CITY OF
EAST GRAND RAPIDS

RE: Gaslight Investors – Revised Concept Plan and Draft Ordinance & Resolution.

PUD AMENDMENT CONCEPT PLAN

RE: **Gaslight Investors Planned Unit Development Amendment Introduction**
2255 Wealthy St. SE and 515 Lakeside Dr. SE (PPNs 41-14-33-276-032 and 41-14-33-276-029)

-  PEDESTRIAN
-  BIKE PATH
-  BIKE PARKING NODE
-  VEHICULAR
-  VEHICULAR RESTRICTED

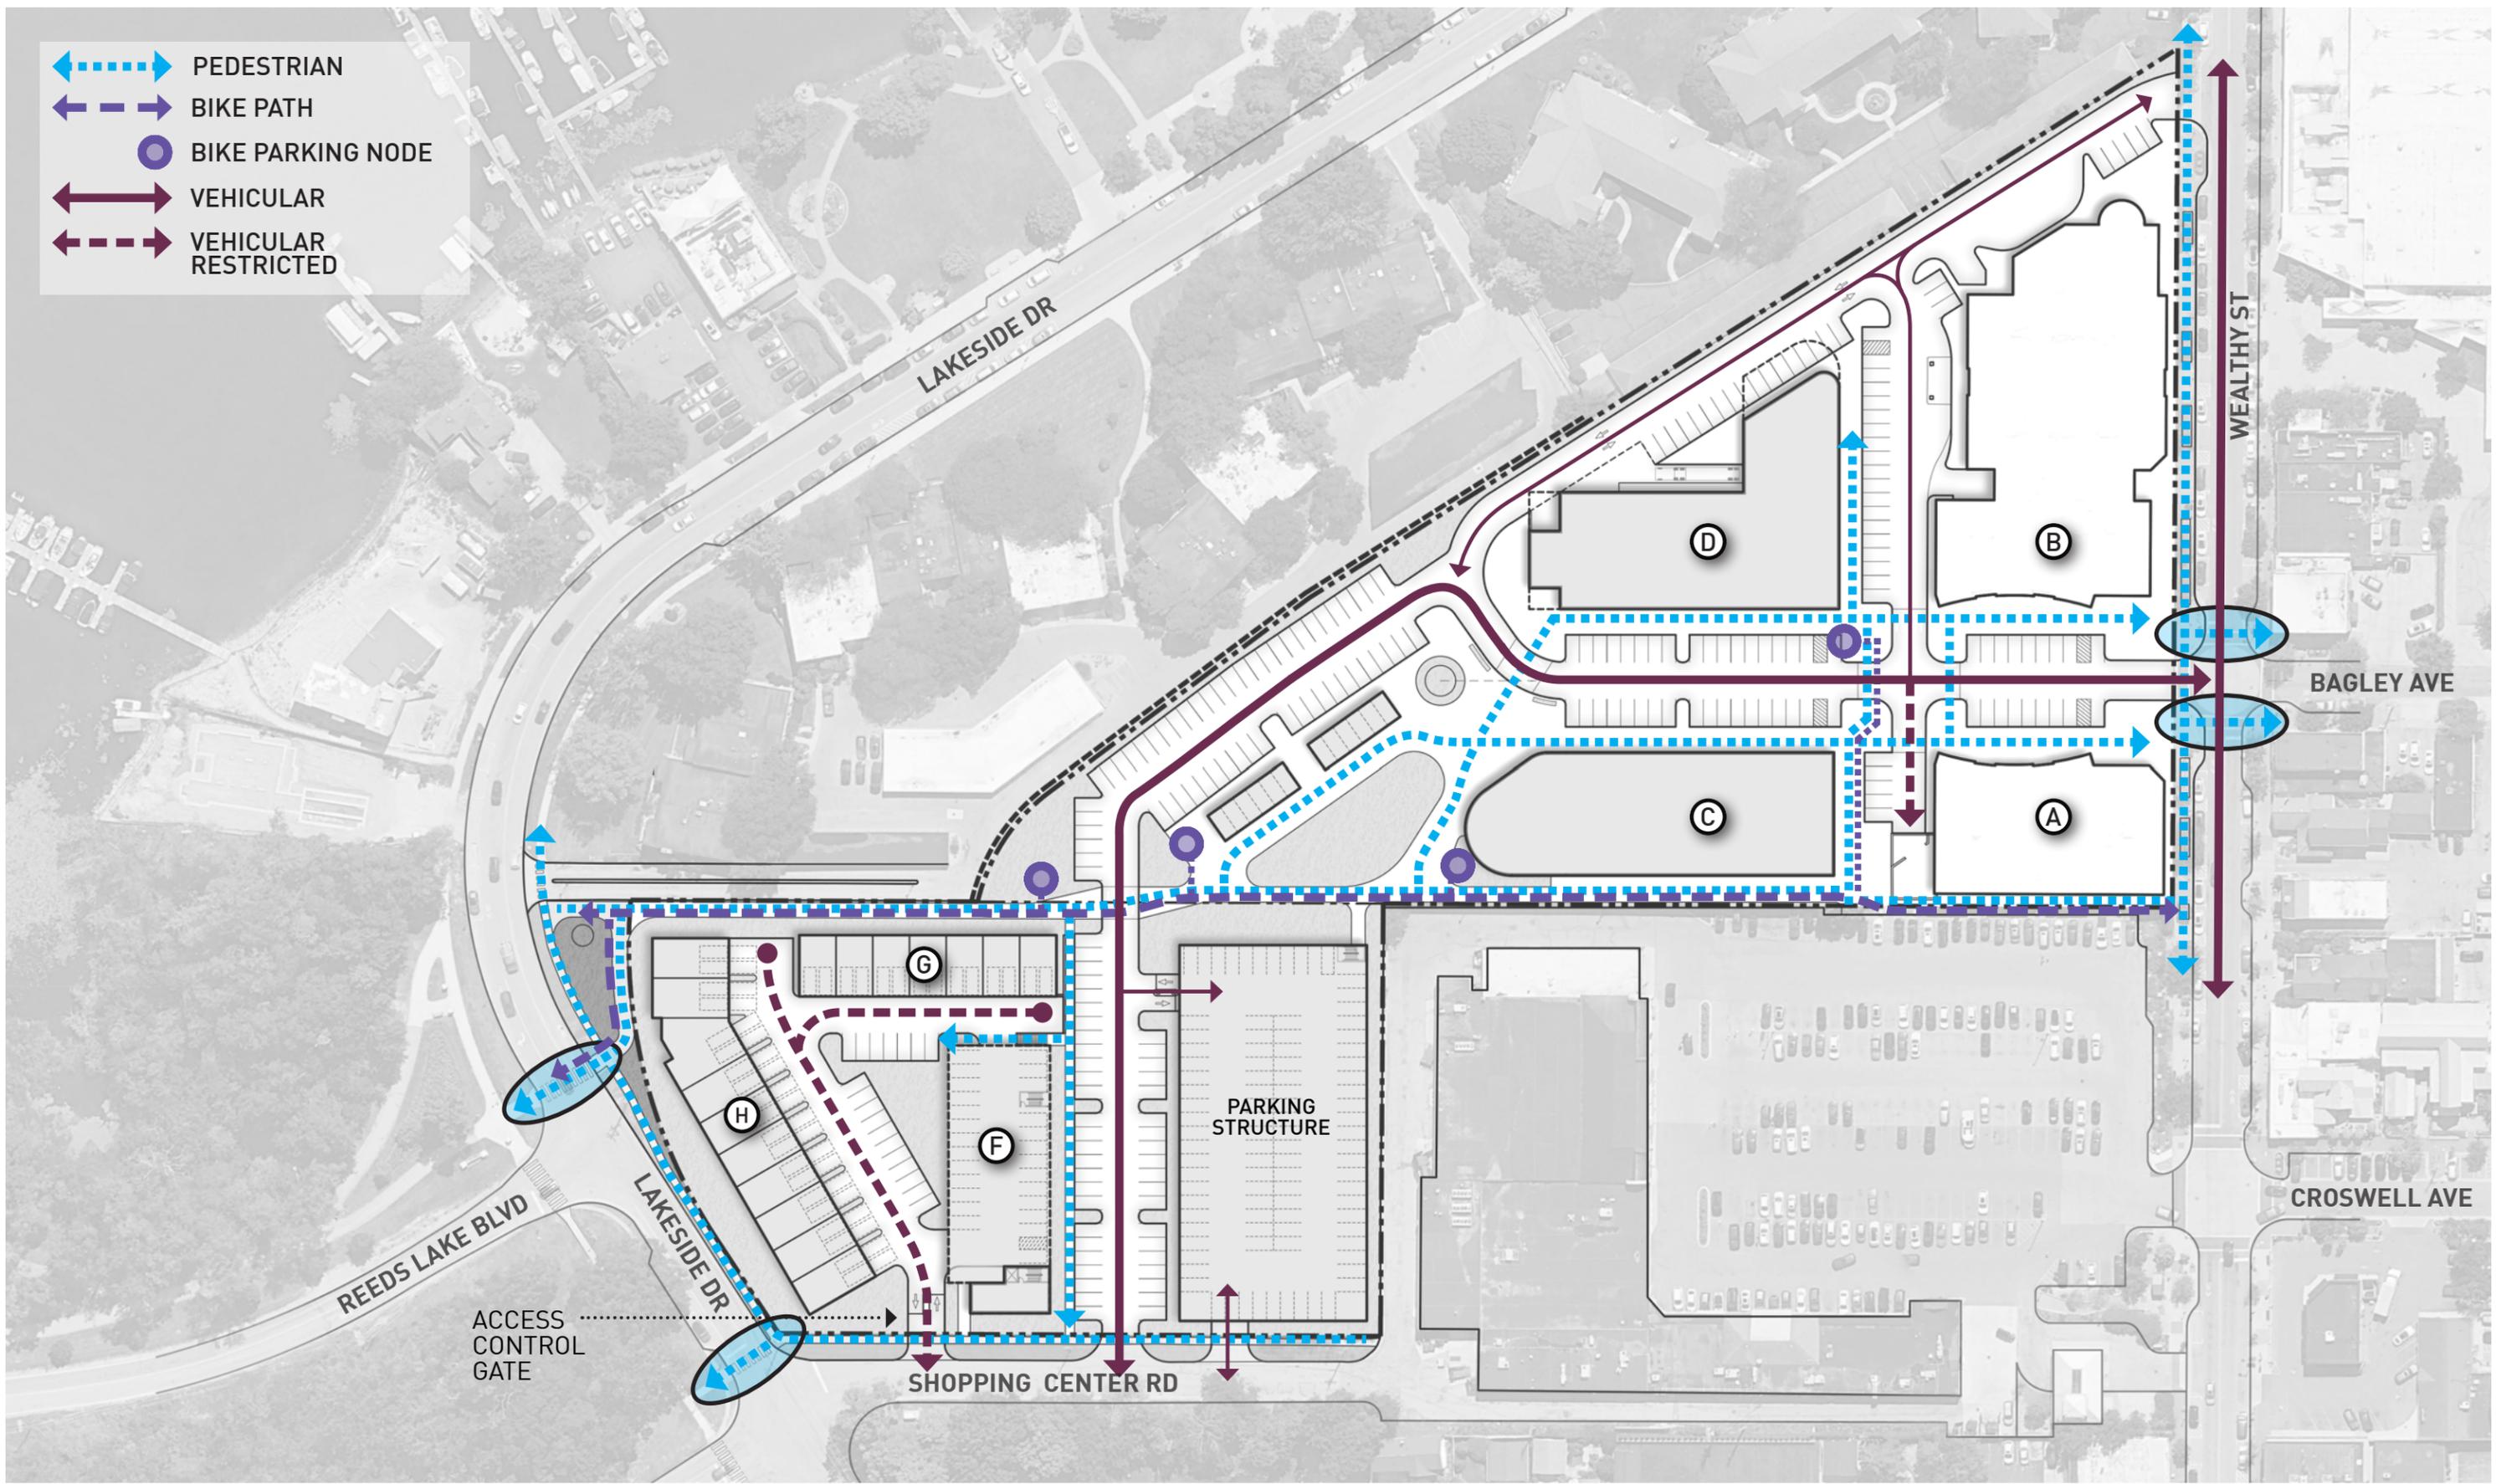
The applicants have also provided basic renderings and diagrams showing the general circulation routes for different users. Of note, the proposed bicycle circulation drawing shows a main north-south bike route connecting Lakeside and Wealthy without intermingling with the internal road network. Access points to bike rack stations are noted and would utilize other planned pedestrian infrastructure. Otherwise, these

drawings do not provide much detail on what specific types of amenities will be incorporated. The City has recommended adopting various recommendations from the National Association of City Transportation Officials (NACTO) and other professional engineering design manuals in other areas such as pedestrian pathways and integrated public amenities.
